Project	IEEE 802.16 Broadband Wireless Access Working Group < http://ieee802.org/16 >	
Title	MSS Idle Mode	
Date Submitted	2004-03-18	
Source(s)	<p>Phillip Barber Broadband Mobile Technologies, Inc. 8302 Sebastian Inlet Frisco, Tx 75035</p> <p>Yigal Leiba Runcom Ltd. Hachoma 2 St. 75655 Rishon Lezion, Israel</p> <p>Changhoi Koo Jungje Son Samsung Elec. 416, Maetan-3dong, Youngtong-gu Suwon-si, Gyeonggi-do Korea</p> <p>Prakash Iyer Intel JF3-206, 2111 NE 25th Avenue Hillsboro, Oregon 97124</p>	<p>Voice: +1 (972) 365-6314 Fax: +1 (925) 396-0269 [mailto:pbarber@BroadbandMobileTech.com]</p> <p>Voice: +972-3-9528440 Fax: +972-3-9528805 [mailto:yigall@runcom.co.il]</p> <p>Voice: +82-31-279-5091 Fax: +82-31-279-5130 [mailto:chkoo@samsung.com] [mailto:jungje.son@samsung.com]</p> <p>Voice: +503 264 1815 Fax: +503 264 4230 [mailto:chkoo@samsung.com]</p>
Re:	Response to IEEE 802.16e-4/06 (Call for Contributions on IEEE 80.16e/D1)

Abstract	MSS Idle Mode	
Purpose	Provide for a mechanism for MSS to be detached from active Normal Operation service with a BS, but available to periodic broadcast messaging to prompt MSS to return to Normal Operation service	
Notice	This document has been prepared t

Figure 1: Paging-groups example

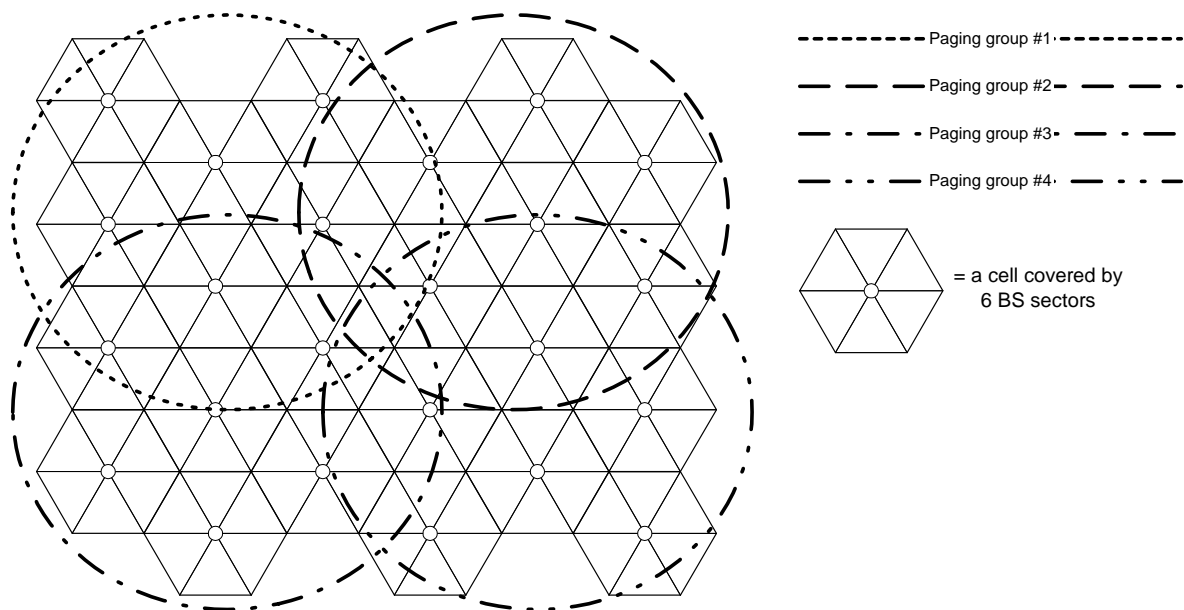
The BS are divided into logical groups called paging groups. The purpose of these groups is to offer a contiguous coverage region in which the MSS does not need to transmit in the UL, yet can be paged in the DL if there is traffic targeted at it. The paging groups should be large enough so that most MSS will remain most of the time within the same paging group, and small enough such that the paging overhead is reasonable. Figure 2 shows an example of four paging groups defined over multiple BS arranged in a hexagonal grid. A BS may be a member of one or more Paging Groups.

The paging-groups are defined in the management system. One possible method of definition is by using the **paging-group-action** backbone message. Another backbone message, **paging-announce**, is used to initiate paging of the MSS on all BS belonging to the paging group.
